# Air Flex - Modify Original Cushions for New Style Drop Rods

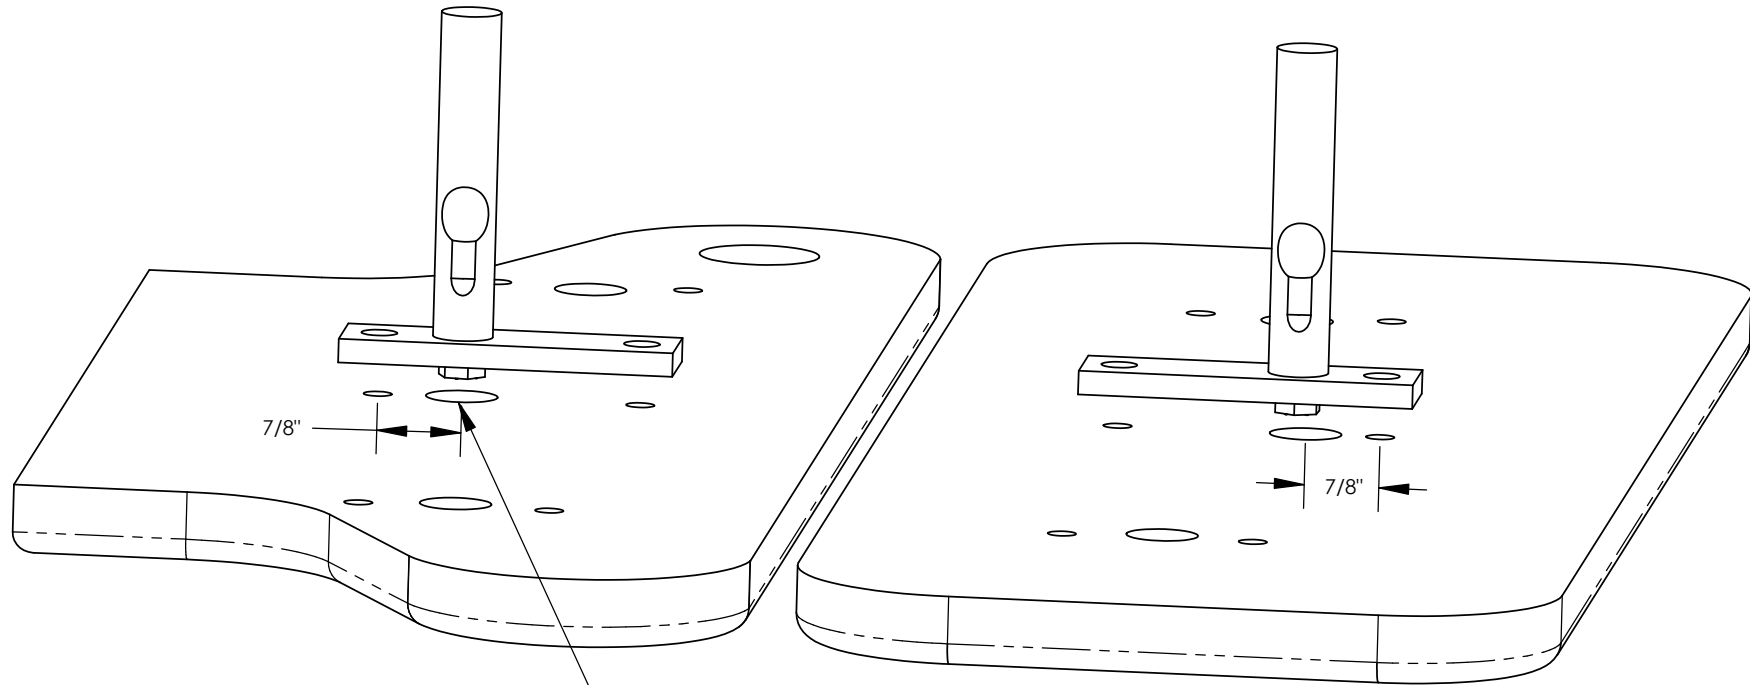
A recess must be created in the underside of each cushion at the location of the drop rod in order for the new style drop rod to be bolted to the cushion.

A minimum 5/8" diameter hole is recommended to accept the hex head of the bolt. The hole can be as shallow as 3/8". Use caution, the plywood is 3/4" thick. A spade bit is recommended.

The new hole is located 7/8" to the closer of the two threaded holes.
